Reference: Engineering Services at the Altis Serenity Clubhouse
Project No.: 2401-010249_I

As requested by the client, a representative of Tyndall Engineering & Design, PA (TE&D) has reviewed the following items:

ITEM 1: MASONRY TO CAST IN PLACE

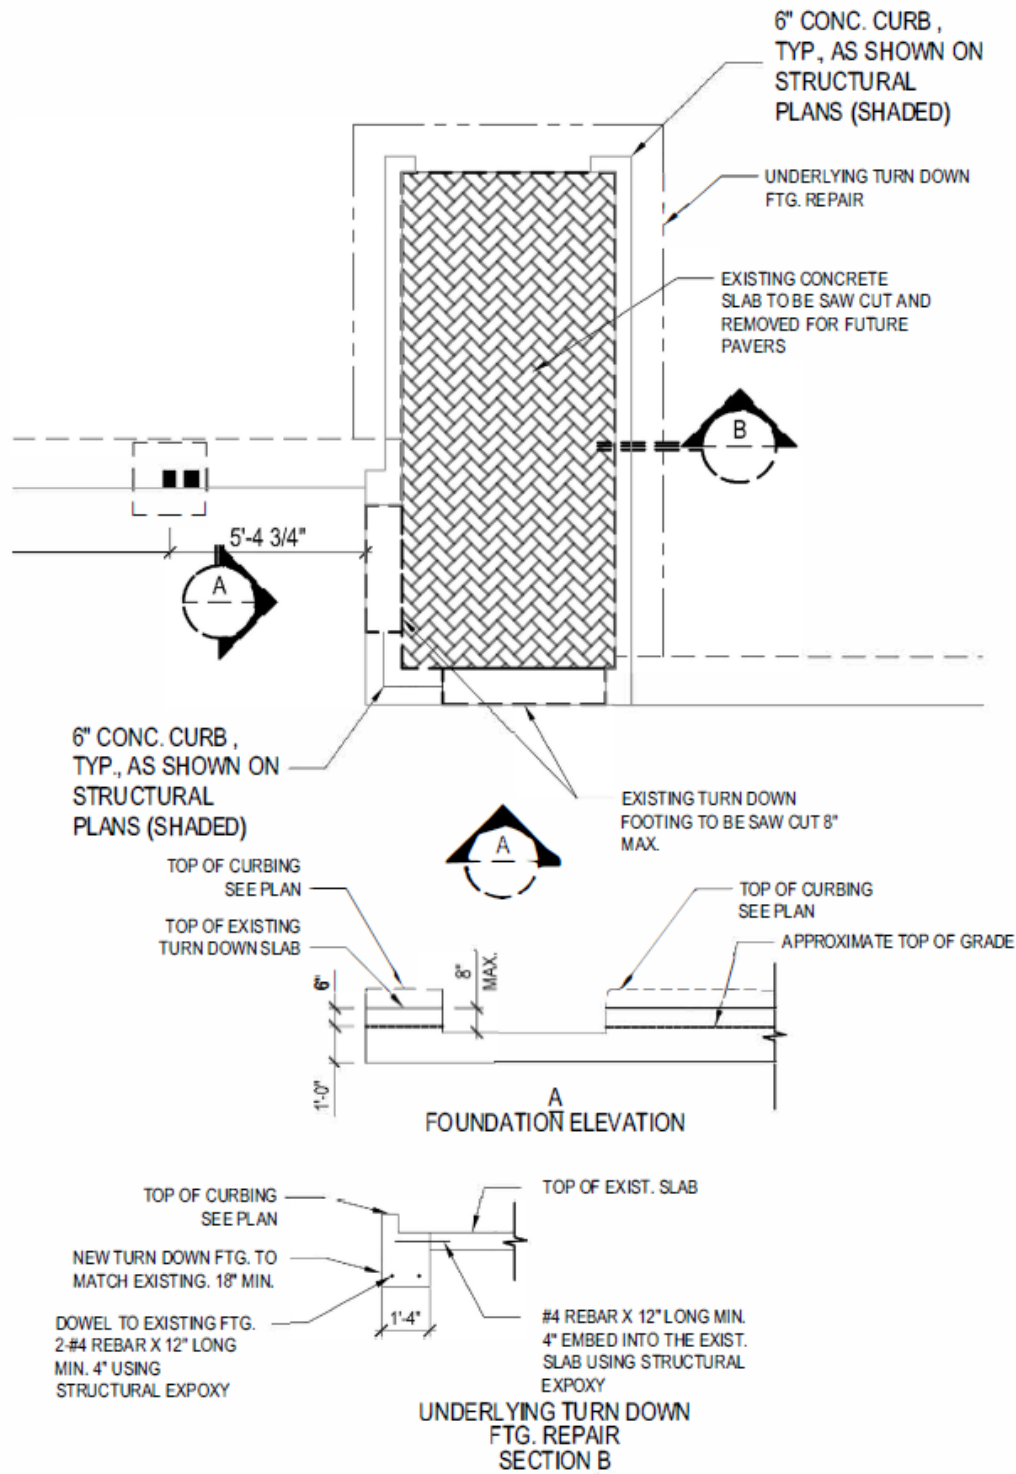
- 1) The area at the plan right entrance, see location on page 2, was designed as a masonry wall, but the contractor would like to install a 12" cast in place concrete wall in lieu of the specified 12" masonry foundation wall.
- 2) The installation of the turn down footing and slab at the plan left front entrance, see location on page 3, does not allow for pavers to be installed into the opening.
- 3) A detail was requested for attaching a knee wall above the shorter wall. The difference in height was 2'-0", at the location provided on page 4.
- 4) The need for the beam was requested to be reviewed at the location provided on page 5 of the report, due to the proximity of the end truss.

- 1) The masonry wall at this location, can be installed as a 12" cast in place concrete wall. The reinforcement shall be the same as the reinforcement specified in the masonry wall.
- 2) Refer to page 3 of this report for the removal area of the existing concrete slab, partial removal at the turn down footing, and installation of the footing below the exterior wall.
- 3) Refer to page 4 of this report for the new stud wall extension detail.
- 4) The (2) 11-1/4" LVL roof support beam is needed to support the roof trusses. Refer to page 5 of this report, roof truss marked as A4SG is an end gable truss, designed by the truss manufacturer and does not appear to be a girder truss designed to hold the trusses being supported by the beam in the Structural plans.
